Access Compliance Report

Public Rights-of-Way

Intersection ID: 18488	Main Street: ABBEY_PL	Cross Street: PARK_RD	Location: NE
ADA ID: DE7C70BE7281	Ramp Type: Perp	Initial Pass/Fail: Fail	Overall Compliance: No
		Severity Score: 12.5

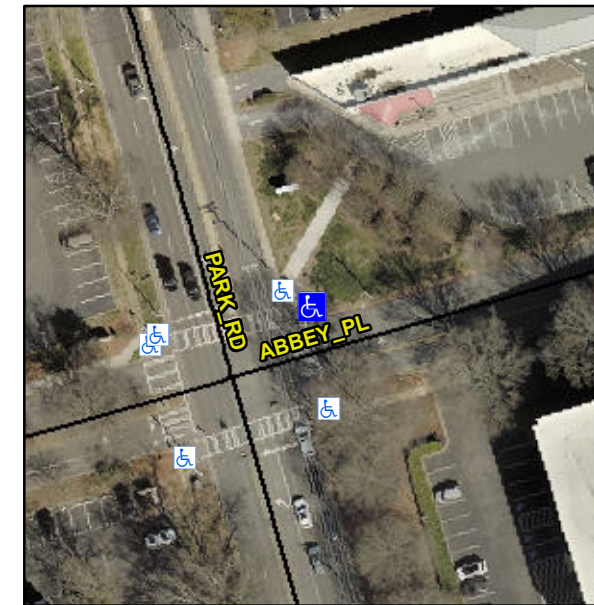
R304.2.2

Compliance	Description	Data	Compliance	Description	Data
N/A	Ramp Length (in)	81.0	No	Ramp Slope (%)	9.8
Yes	Ramp Width (in)	48.0	Yes	Ramp XSlope (%)	0.2
N/A	Flare Type LT	N/A	N/A	Flare Type RT	N/A
N/A	Flare Slope LT (%)	N/A	N/A	Flare Slope RT (%)	N/A
N/A	Flare Traversable LT?	N/A	N/A	Flare Traversable RT?	N/A
N/A	Landing Length (in)	N/A	N/A	DWS Provided?	N/A
N/A	Landing Width (in)	N/A	N/A	DWS Contrast?	N/A
N/A	Landing Slope (%)	N/A	N/A	DWS Length (in)	N/A
N/A	Landing X Slope (%)	N/A	N/A	DWS Full Width?	N/A
N/A	Landing Curb? (Y/N)	N/A	N/A	DWS Offset (in)	N/A
N/A	Shared Landing?	N/A			
N/A	Gutter Ponding?	N/A	N/A	Gutter Slope (%)	N/A
N/A	Gutter Lip Ht (in)	N/A	N/A	Gutter X Slope (%)	N/A
N/A	Painted X Walk1?	Yes	N/A	Painted X Walk2?	N/A
	X Walk 1 Direction	To S		X Walk 2 Direction	N/A
N/A	X Walk 1 Width (in)	112.0	N/A	X Walk 2 Width (in)	N/A
	X Walk 1 Slope (%)	2.3		X Walk 2 Slope (%)	N/A
	X Walk 1 X Slope (%)	0.2		X Walk 2 X Slope (%)	N/A

N/A	Ramp inside XWalk1?	No	N/A	Ramp inside XWalk2?	N/A
	Road Slope (%)	N/A	N/A	Clear Space?	N/A
	Road X Slope (%)	N/A	N/A	Clear Space to XWalk (in)	N/A
N/A	Any Obstructions?	N/A	N/A	Storm Grate/Utility Hazard?	N/A
	Obstruction Type			Storm Grate/Utility Type	
		N/A			N/A
		Yes		Surface Condition? (G/P)	Good

**Remove & Replace Entire Ramp.
Restripe Crosswalk.**
